BALTIMORE COUNTY PUBLIC SCHOOLS

ADDENDUM NUMBER _1_

BID NAME: NEW SCHOOL CONSTRUCTION LANSDOWNE ELEMENTARY
SCHOOL/DEMOLITION OF LANSDOWNE ELEMENTARY
SCHOOL__

BID NUMBER: **MBU-516-17**

ADDENDUM #
1

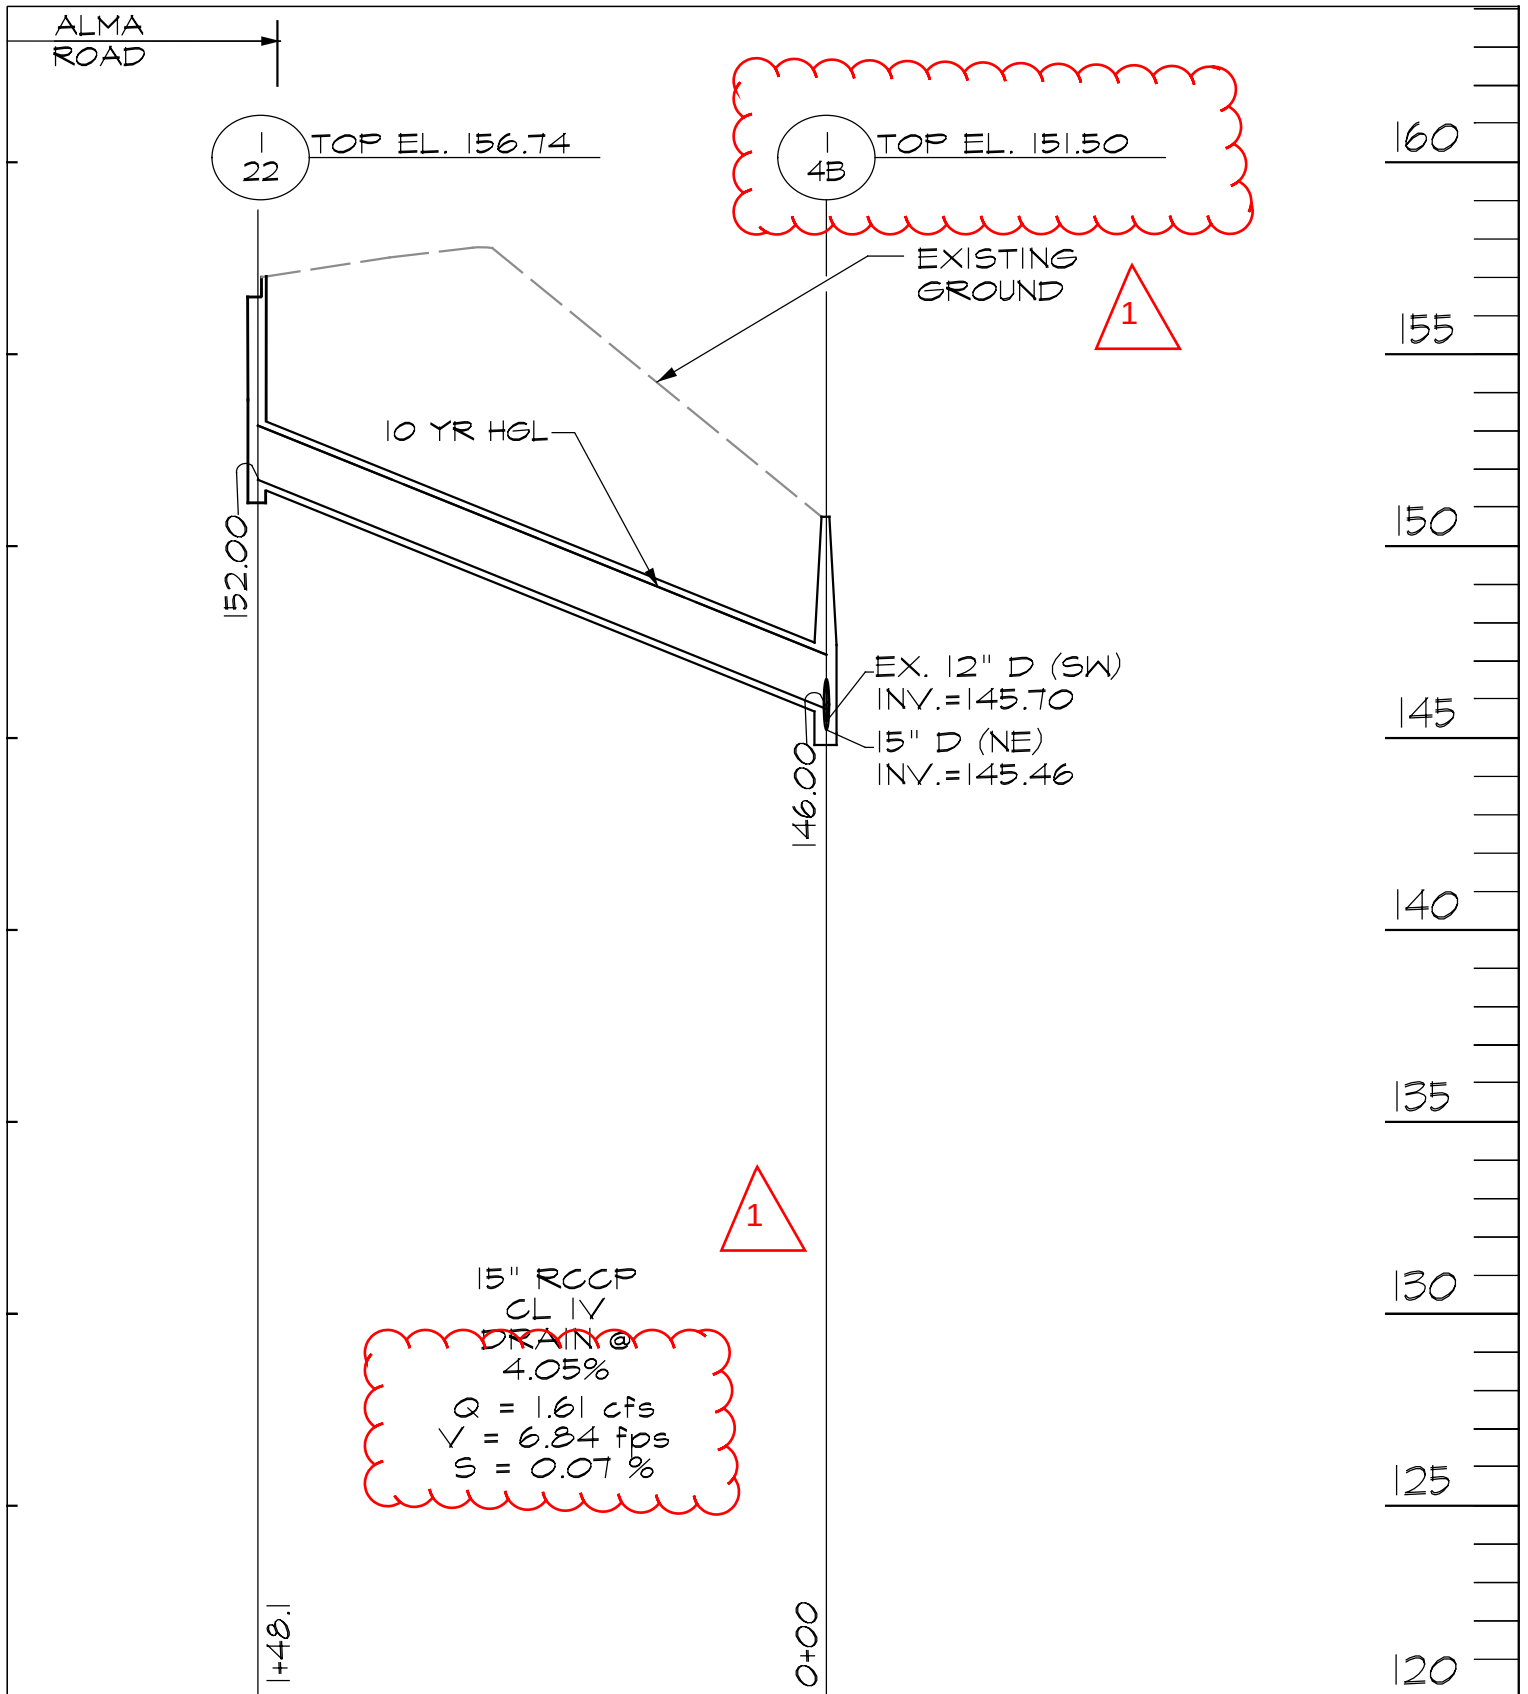
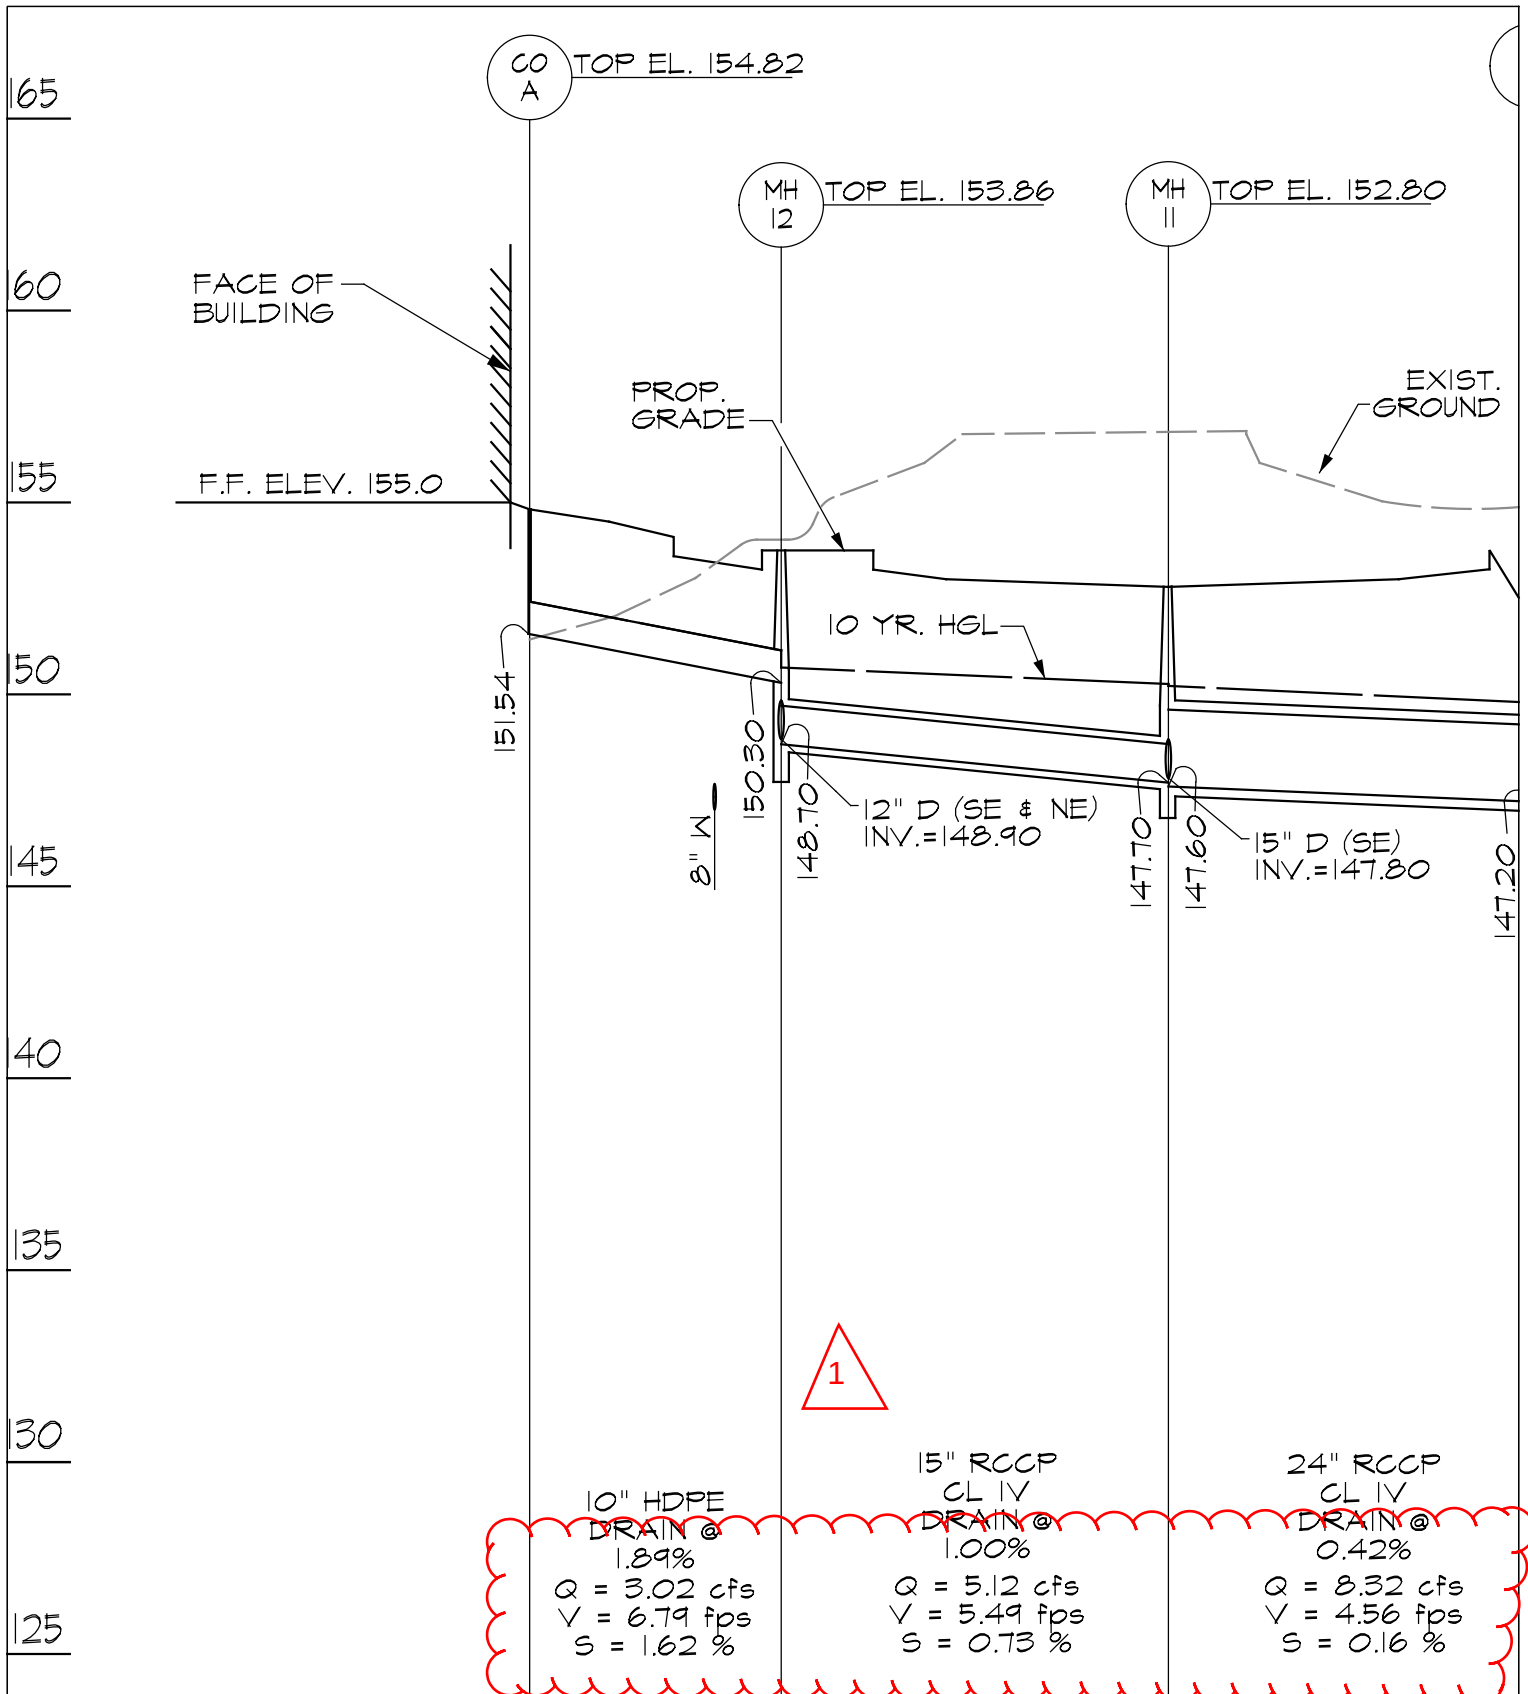
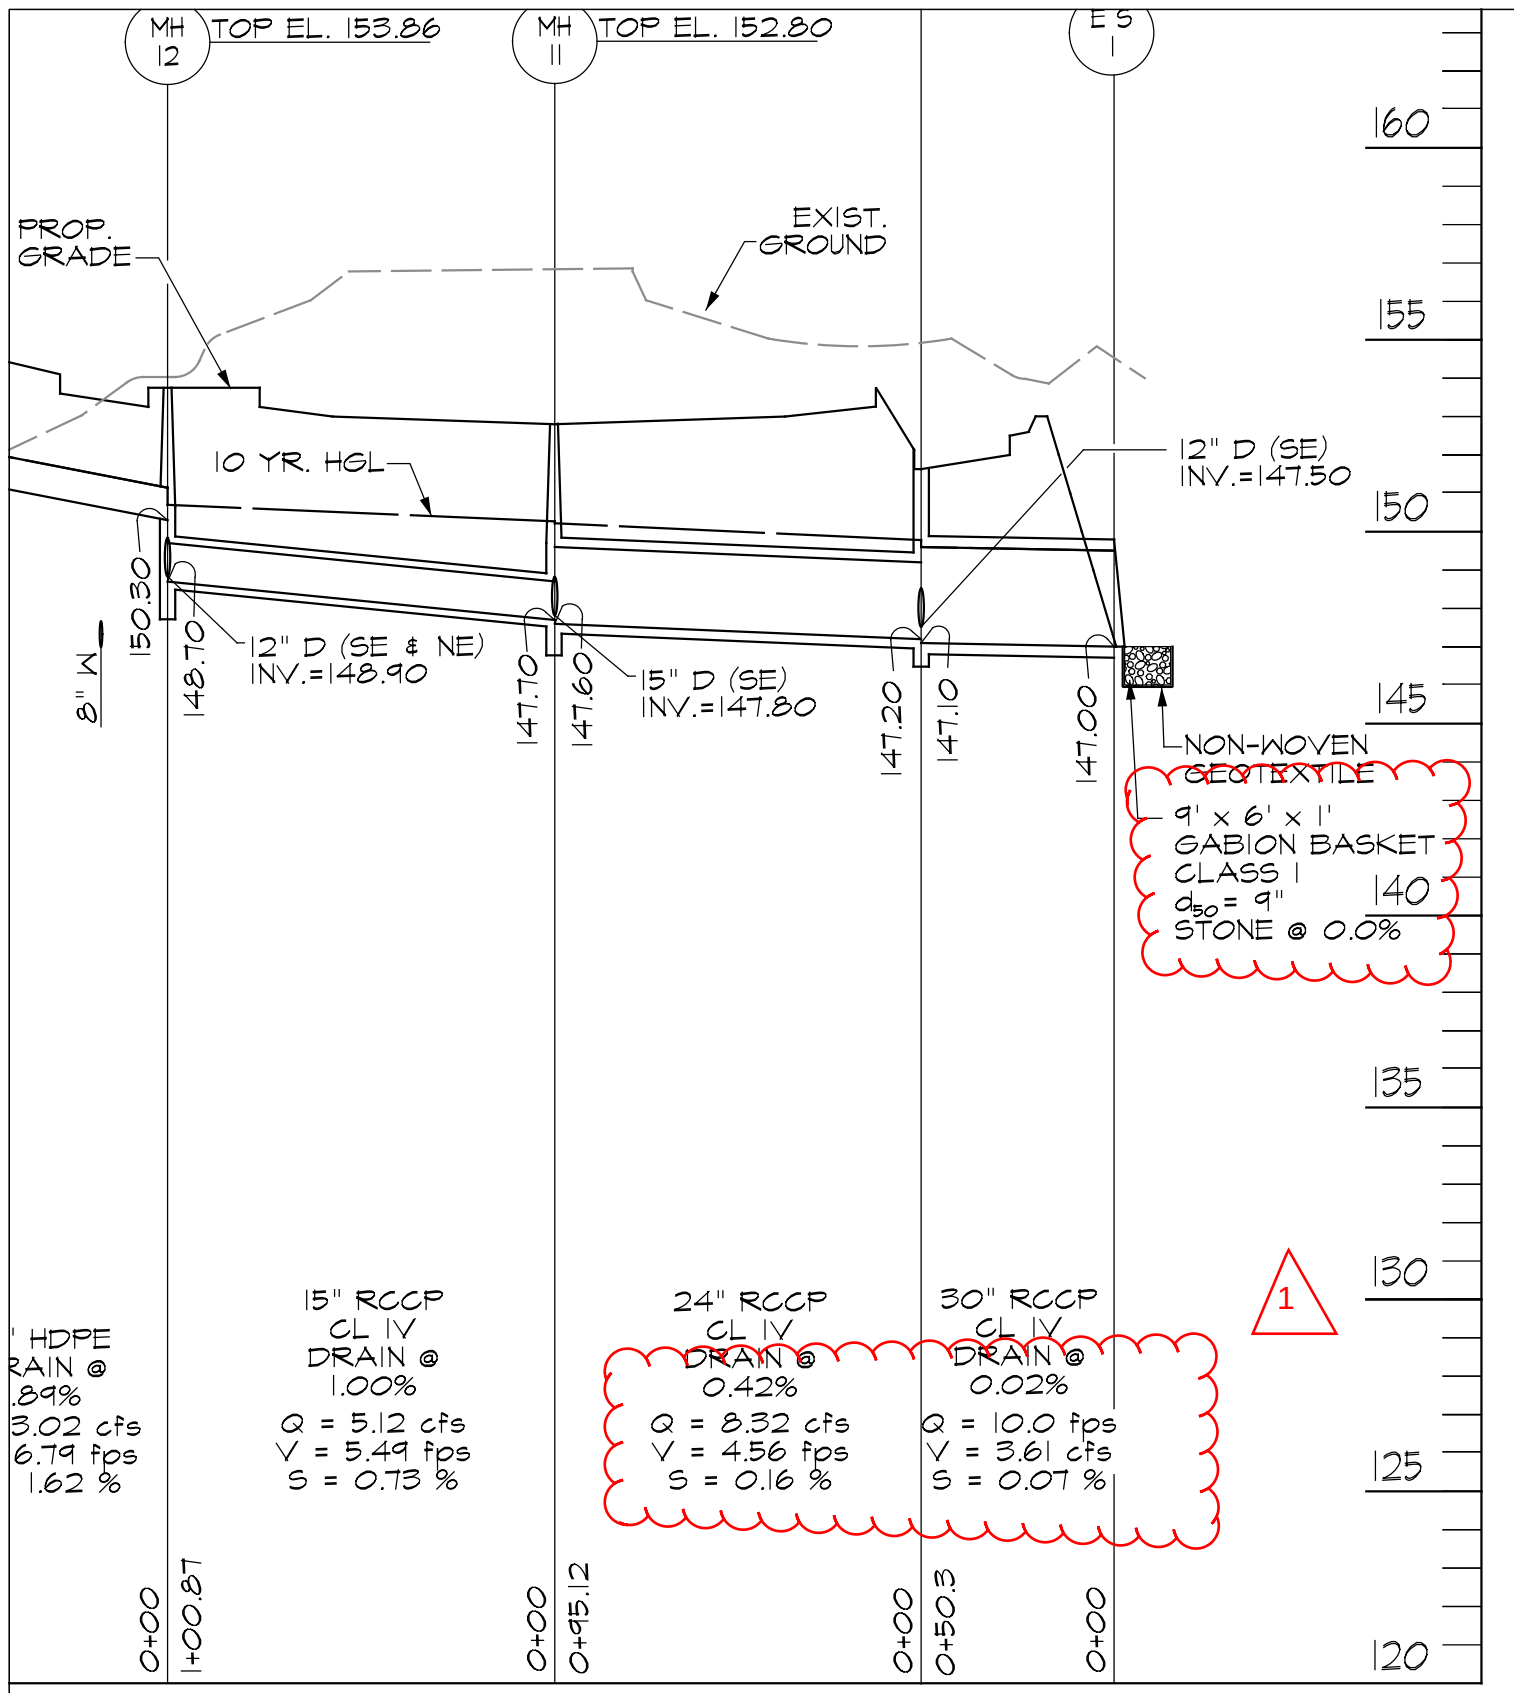
- 3.14. SHEET C-4.6, UTILITY PROFILES
REVISE: Storm Drain Profiles as indicated in attached sketch SK-C-13 – 13I.
- 3.15. SHEET C-5.1, STORM DRAIN DRAINAGE AREA MAP
REVISE: Storm Drain Design Data chart as indicated in attached sketch SK-C-14.
